# Campaign Bulletin

Bulletin No.: 00052

## FMVSS NON-COMPLIANCE CAMPAIGN

**SUBJECT: 00052 - ONBOARD ENTERTAINMENT CENTER INSTALLATION**

Figure 1

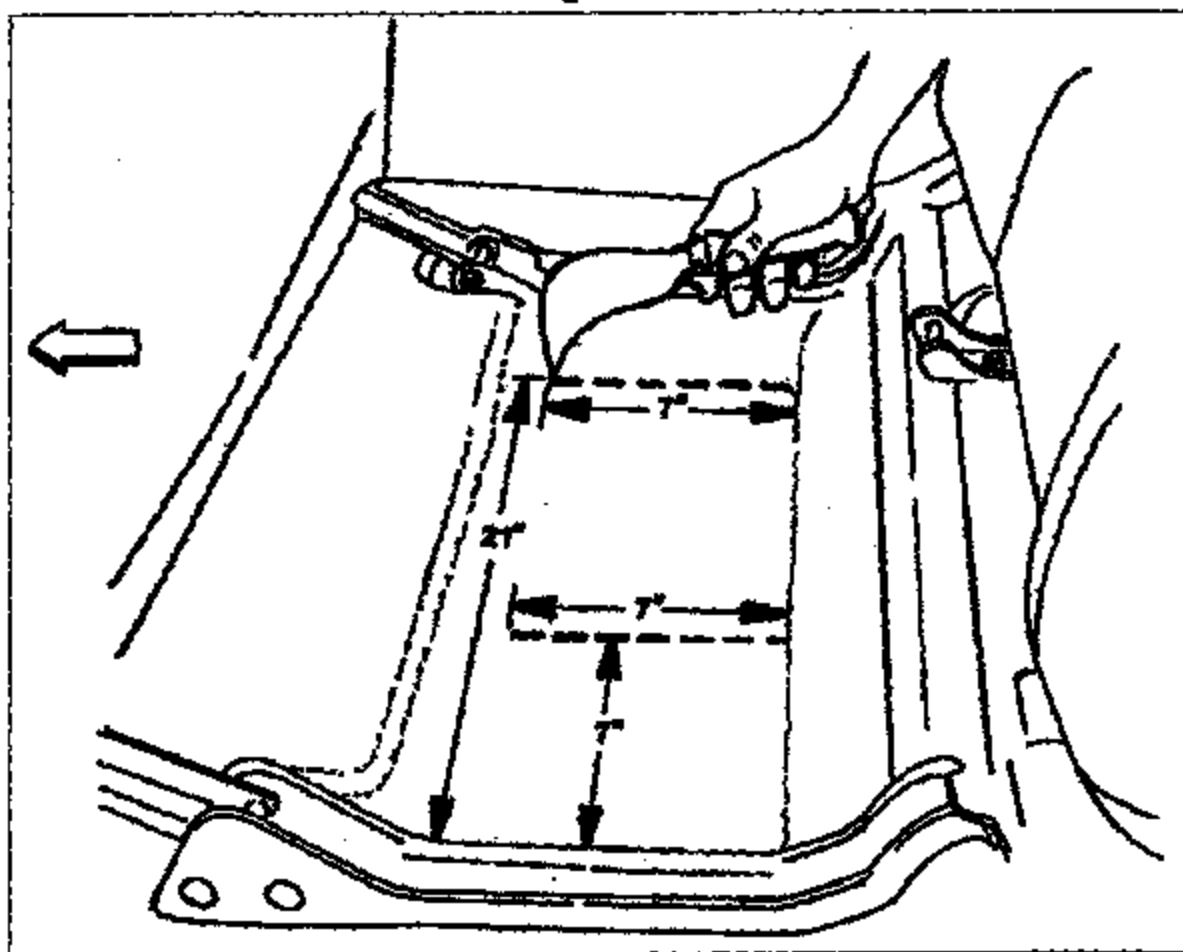
General Motors has decided that certain 1999-2000 Cadillac Escalade model vehicles equipped with an OnBoard Entertainment Center installed on the left-hand side (driver side), fail to conform to Federal Motor Vehicle Safety Standard (FMVSS) 301, "Fuel System Integrity". On some of these vehicles, the video cassette player mounting screws may extend below the floor pan. In a vehicle crash, a screw may penetrate the fuel tank and a fuel leak could occur. Additionally, a mounting screw could contact the fuel return line and eventually cause a wear-through condition, resulting in a fuel leak. In either case, if an ignition source were present, a vehicle fire could result.

- Loosen the two nuts on the VCP retaining bracket (6).

**Important:** Do not remove any electrical connections from the tuner.
- Disconnect the power and signal cables from the back of the VCP (3) and remove.

**Important:** The number and type of fasteners used to secure the VCP mounting bracket and the tuner may differ from one vehicle to another.
- Remove the screws retaining the VCP mounting bracket (5) and the tuner (1) to the vehicle floor pan.
- Remove the VCP mounting bracket (5). Lower the driver's side rear seat back slightly and, taking care not to damage or disconnect any electrical connections, place the tuner behind the driver's side rear seat back.
- At the two locations shown in Figure 1, cut the carpet and padding, taking care not to cut or damage any of the wiring harnesses routed under the carpet or in the area where cuts are to be made.
- Fold forward the carpet/padding flap created by making the two cuts, exposing the vehicle floor pan. Remove any carpet/padding debris.

Dealers are to inspect the installation of the OnBoard Entertainment Center. If the entertainment center is installed on the right-hand side (passenger side), no correction is required. If the entertainment center is installed on the left-hand side (driver side), dealers are to remove and reinstall the entertainment center with a revised attachment bracket, and inspect the fuel return line, and replace if necessary.

9. Inspect the holes in the floor pan and if well nuts (rubber encapsulated nuts) are present, remove and discard.
10. Clean the holes and the surrounding areas (approximately 2" X 2") with an 80/20 alcohol/water solution, and let dry.

11. On vehicles that had been assembled with well nuts, apply a bead of RTV sealant, P/N 12345739, around each of the eight holes and install the rubber plugs contained in kit P/N 0534-9500-01-VSX.

12. Remove the paper backing from the 2" X 2" adhesive patches, and install a patch over each plug or hole that was made to secure the VCP bracket (5) or tuner (1) to the floor pan.

Figure 2

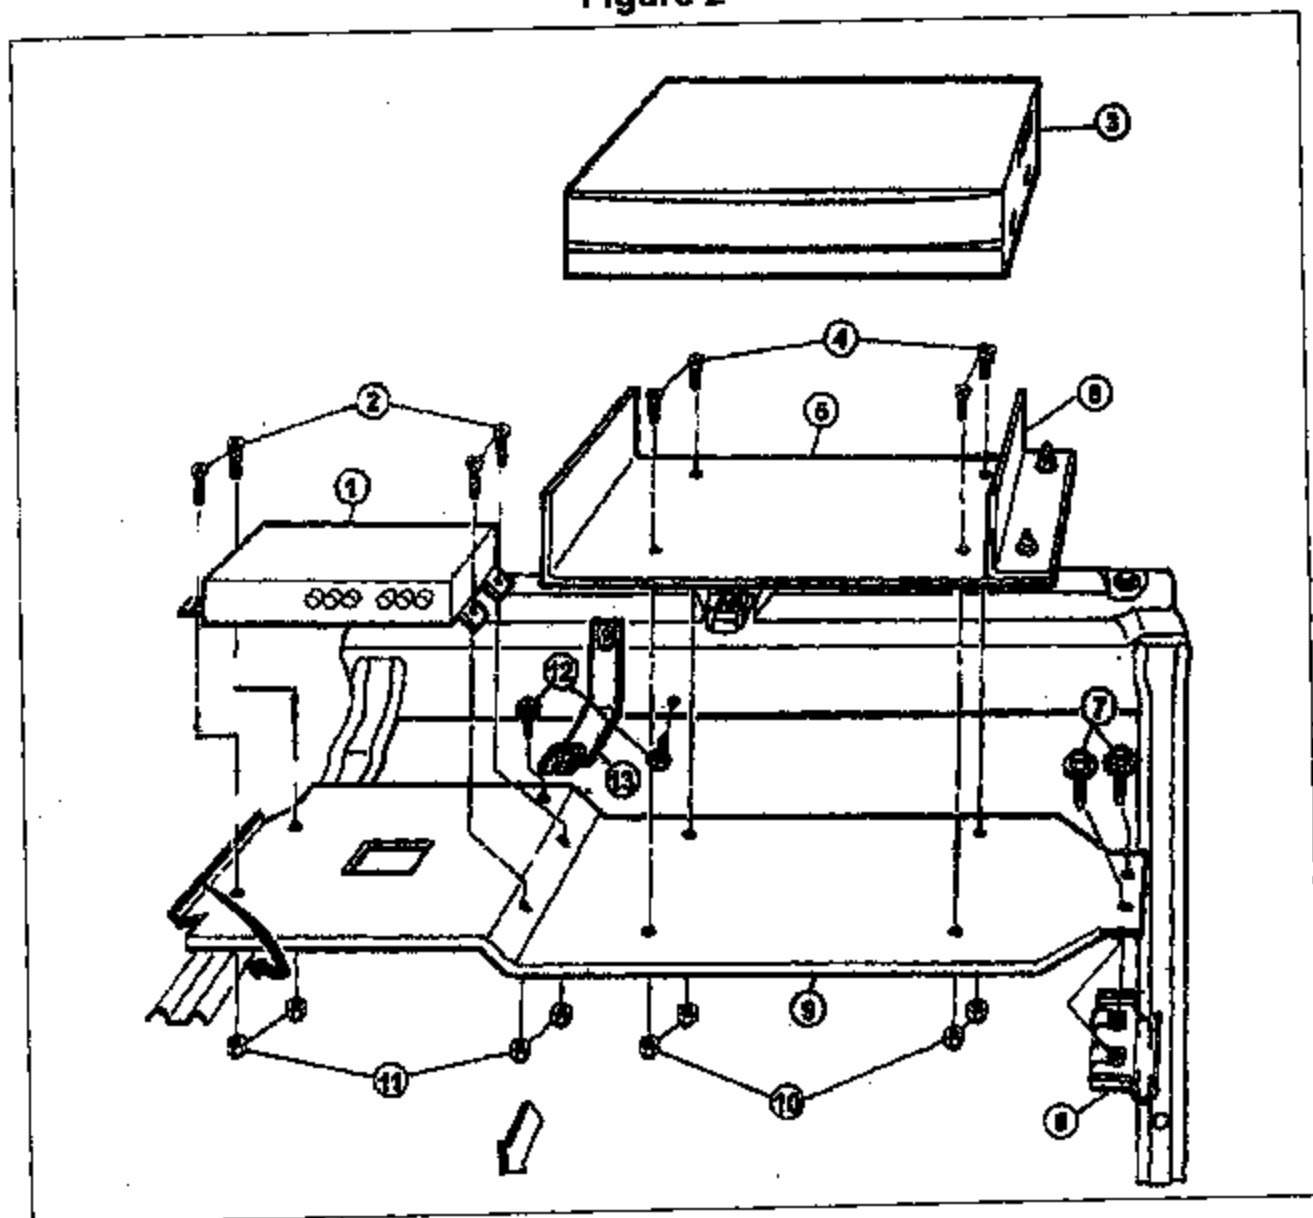
**Important:** The outboard mounting legs/tabs on some tuners may need to be bent downward to conform to the contour of the VCP/tuner mounting plate.

18. Remove the tuner (1) from behind the rear seat and position it onto the VCP/tuner mounting plate (9) as shown in Figure 2.

19. Secure the tuner (1) to the mounting plate (9) using the panhead screws (2) and nyloc nuts (11), tightened to 2 Nm (15 lb in).
20. Position the previously removed VCP bracket (5) onto the VCP/tuner mounting plate (9) as shown in Figure 2
21. Secure the VCP bracket (5) to the mounting plate (9) with the four flathead screws (4) and nyloc nuts (10) tightened to 2 Nm (15 lb in).
22. Hook the end of the VCP/tuner mounting plate (9) under the inboard leg of the rear seat bracket and align it with the fore/aft bracket (13).
23. Install the new mounting plate retaining bracket (8) under the outboard leg of the rear seat bracket and align the holes with the holes in the VCP/tuner mounting plate (9).

24. With the VCP/tuner mounting plate (9) positioned over the fore/aft bracket (13) and the mounting plate retaining bracket (8), secure the fore/aft bracket (13) to the mounting plate (9) with a washer head sheet metal screw (12) tightened to 2 Nm (15 lb in).

25. Install the two hex head screws (7) through the mounting plate (9) into the retaining bracket (8) and tighten the screws (7) to 7 Nm (5 lb ft).
26. Position the VCP (3) onto its mounting bracket (5) and connect the power and signal cables.
